Nant Mithil Energy Park, Powys.  
PEDW DNS Application Ref: DNS CAS-01907-D7Q6Z1.

## **Project Description & Elements of Project (ES Ch.4 & Appendices)**

Evidence by CPRW-RE-think on:

**Figure 3: Area 1 — track from T15, beyond junction where tracks diverge to T21-24 and T25-31: Cefn y Grug to T25**

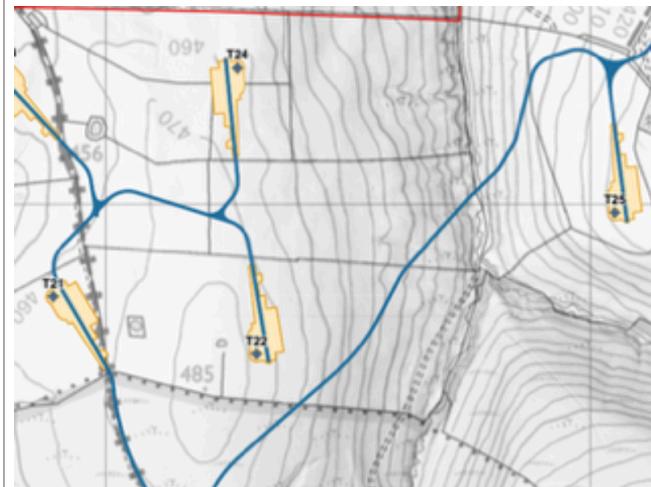
- 5.2. **Area 1: Track from T15, beyond junction where tracks diverge to T21-24 and T25-31: Cefn y Grug to T25 (Figure 3).** To be used by all traffic for construction of T25-31 (T27 has gone). These are by far the worst inclines and also involve crossing a brook which is a site of riparian restoration according to the OHMP. Over 950m:-

- descent from 460m to 340m in roughly 600m **average 20%**
  - steepest descent 60m in 200m **30%.**
  - Merwys Brook crossing including cable trenches - **ES Table 7.1** (responses to statutory consultees) says: "*Details of watercourse crossings have been included in the OHMP*" (**Appendix 7.10**) but they have not. **Appendix 11.02**

- ascent from 340m to-420m (at T-junction T25-26) over roughly 350m **23%**
- the steepest ascent from the stream bed is 40m over 100m **40%**.

5.5. Action needed. Further detailed information about the construction of tracks and trenches with volumes and areas required for cut and fill, and drainage. Extra attention should be given to these three steep areas and to water crossings, allowing for extreme weather conditions.

**Figure 4: App. 11.6, Fig 5.6 soil stability**

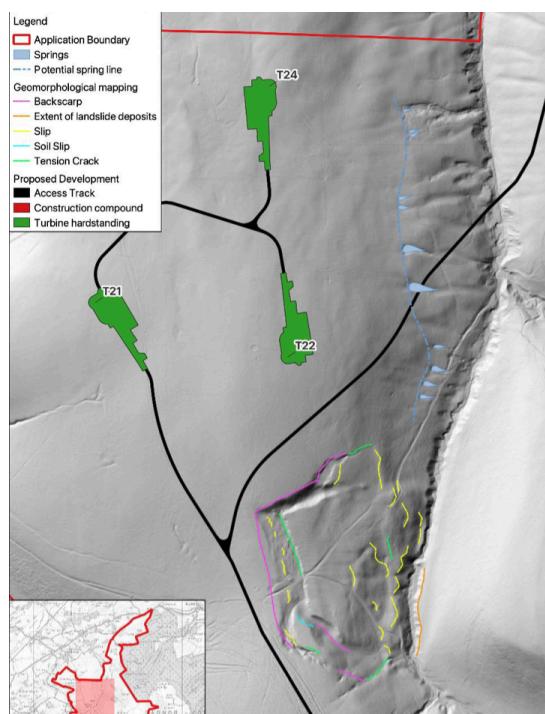
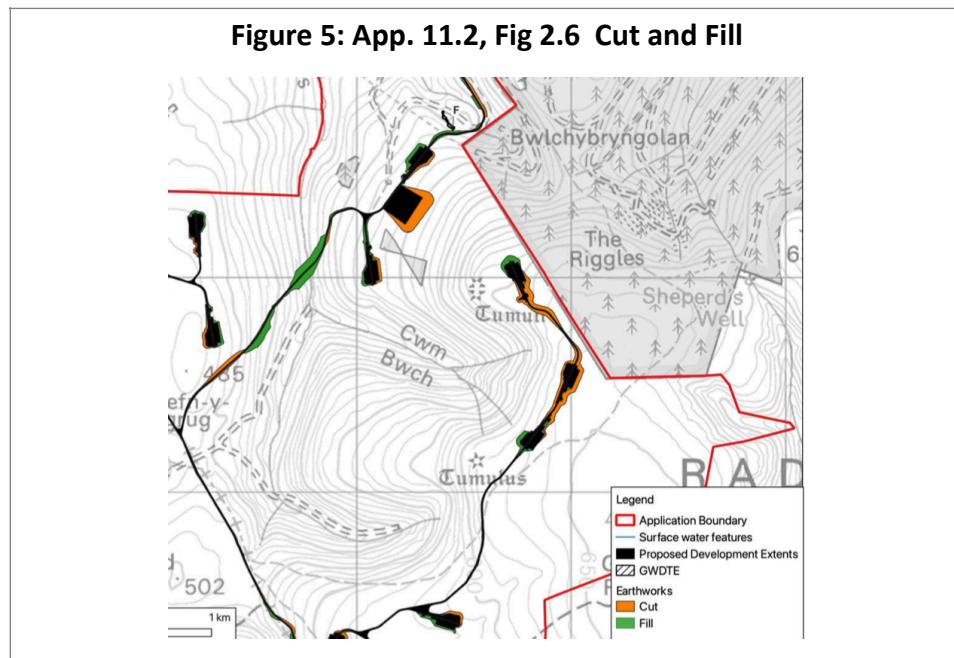
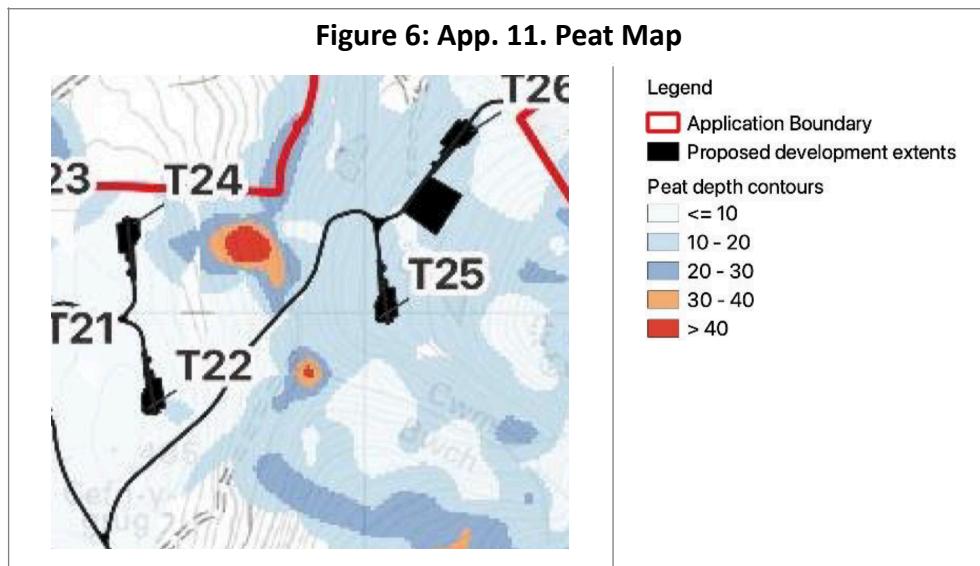
App. 11.6, Fig 5.6 shows there is a soil slip across this descent and a tension crack to the south.

This series of Figures is the clearest indication of cut and fill in the ES. Roughly 700m of fill are shown descending about 40m and ascending about 30m with a continuous fill on both sides of the track for 300m over the brook crossing.

The OSMP shows this fill will be in a vulnerable peat area. The ES presents figures of an *“indicative watercourse crossing”* and an *“indicative track”* which do not explain:

- how a transporter for 80m blades will negotiate the stream crossing in Cwm Merwys;

- how the extreme-weather water flows in the brook will be addressed;
- how drainage will be achieved at steep gradients;
- how biodiversity and valuable soil impacts are addressed;
- how track stability and safety will be addressed.

### 5.3. Area 2: Site Access North track to T junction with track between Borrow Pit 1 and T1.

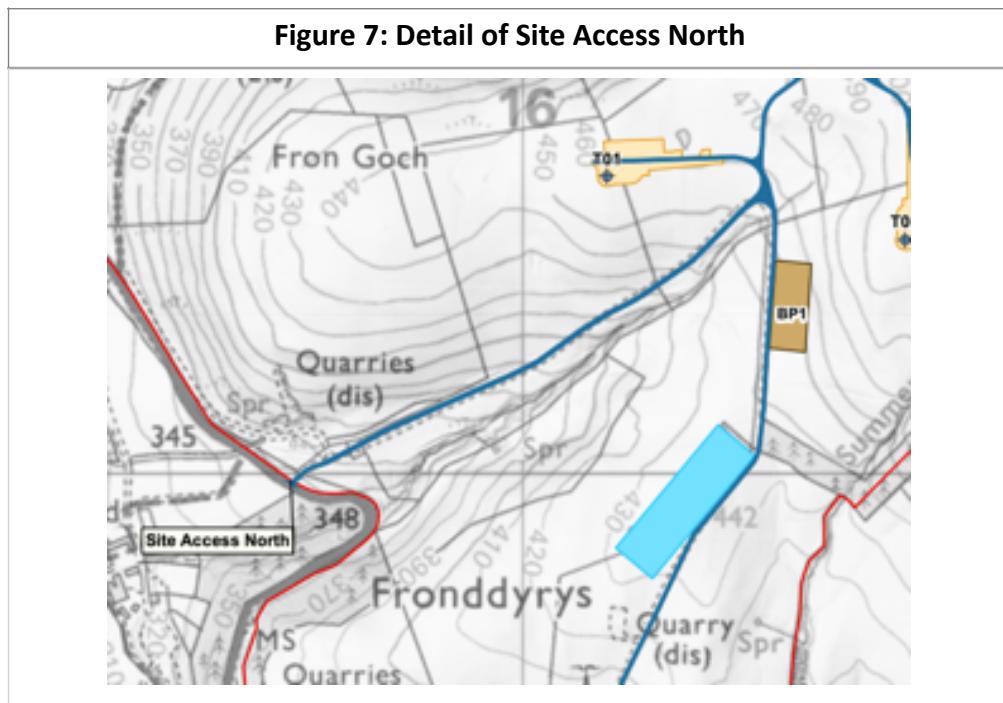
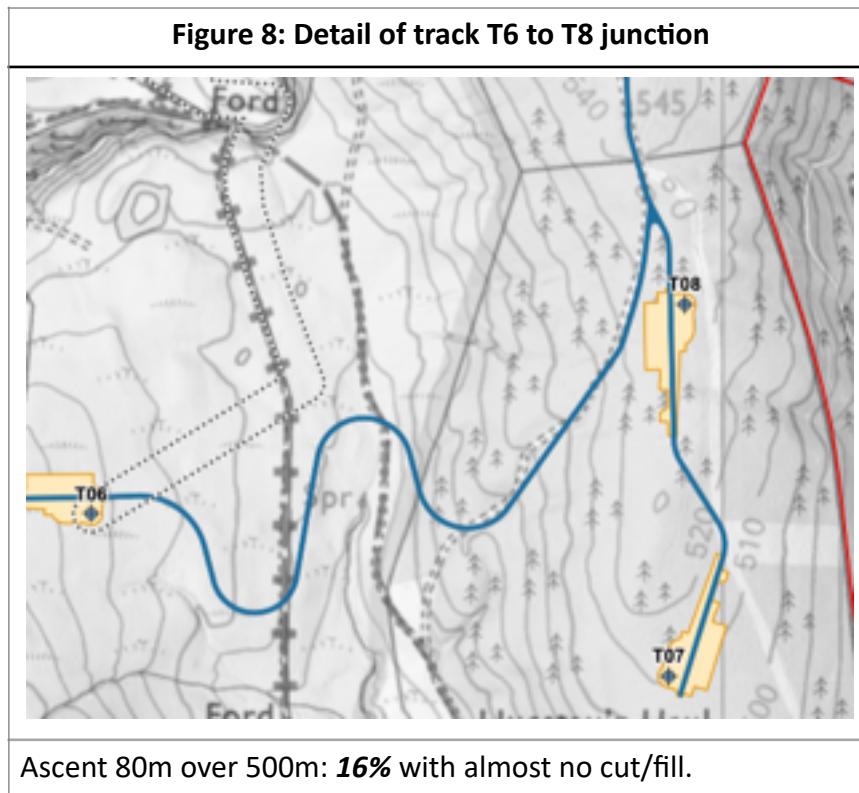
Although this is less steep than Areas 1 and 3, every vehicle will have to arrive via this.

Ascent roughly 100m over 800m: average incline: **12.5%**, steeper to north with no cut/fill.

## 6. TURNING HEADS AND 130 PASSING PLACES (area unknown).

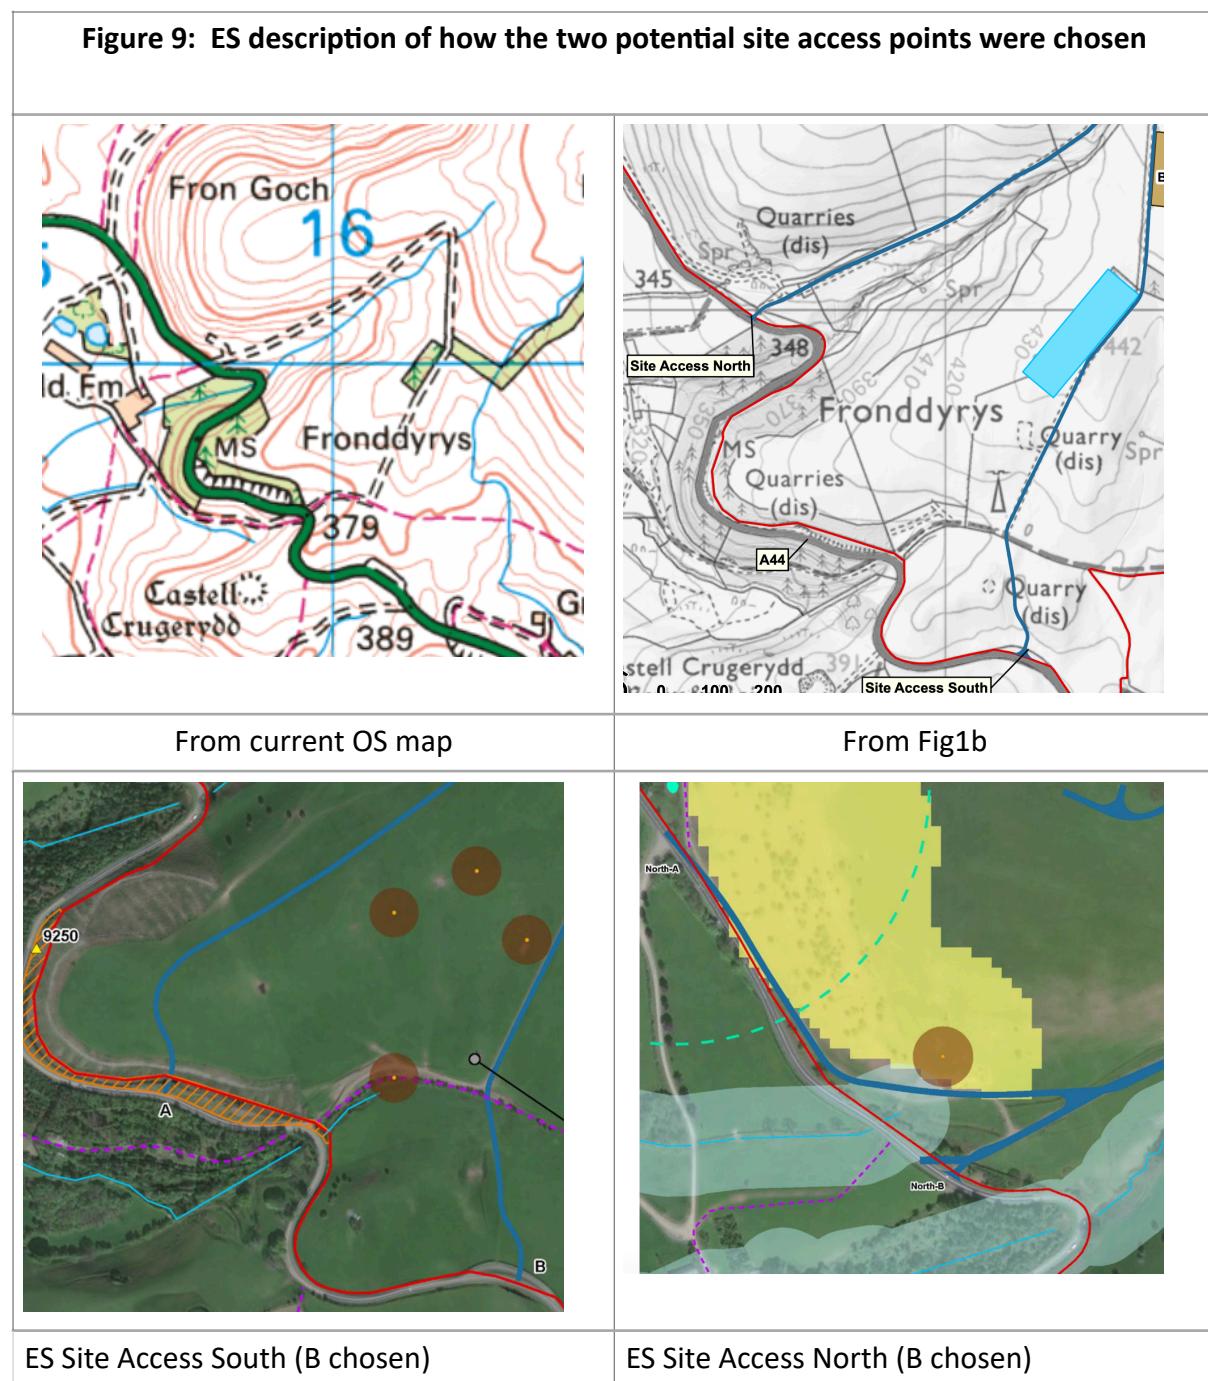
6.1. No measurements or indicative drawings are given. We do not know if they are for HGVs or may need to accommodate AILs. They can't be identified on Fig 4.1 b-h but, in order to quantify the need for passing places, we assume the Applicant is in possession of more information than we can see. There are said to be no passing places on common land which eliminates 4-5km of track. Therefore there would be 130 passing places over 18-19km of access track elsewhere with 6 or 7 passing places per kilometer - on average one each 150m. This is significant increase in land-take with surface disturbance. If passing places were 6mx 30m in area they would cover 2.3 ha.

6.2. Action needed. Justification for passing places and areas of permanent land take and surface disturbance for these.

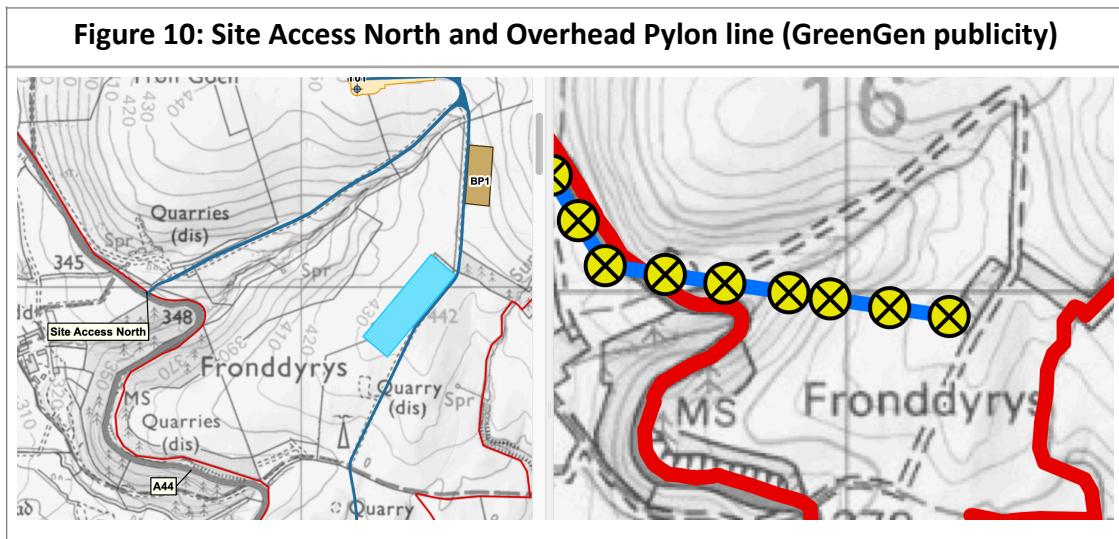
10.1. Turbine foundations are 25 m in diameter with a concrete depth of 3.5 m and overlay of depth approximately 0.5 m. Crane hard-standings and laydown/storage areas: from Fig 4.4 indicative areas, the permanent crane hard-standings are 1,045 m<sup>2</sup> per turbine (3.1ha for 30 turbines). But App. 11.2 - 4.5.4 says *"For each turbine area a permanent impervious area of approximately 2,015 m<sup>2</sup> is proposed (0.2015 hectares)*. This gives a total of 6 ha, considerably greater than the ES estimate. Fig 1 included in Fig 4.4 details another 2,012 m<sup>2</sup> temporary land-take for each turbine -- another 6ha for 30 turbines.

10.2. The Outline Drainage Strategy says the orientation of these large areas is to be decided later and so we do not know how they will relate to PROWs, valuable soils or habitats.

10.3. All the above structures require sustainable drainage both during construction and operation. No details are given in the indicative plans except for the track plan.

10.4. Action needed: Internal consistency between documents, a clarification of the area of temporary land disturbance. Adequate drainage arrangements to be specified and added to areas.
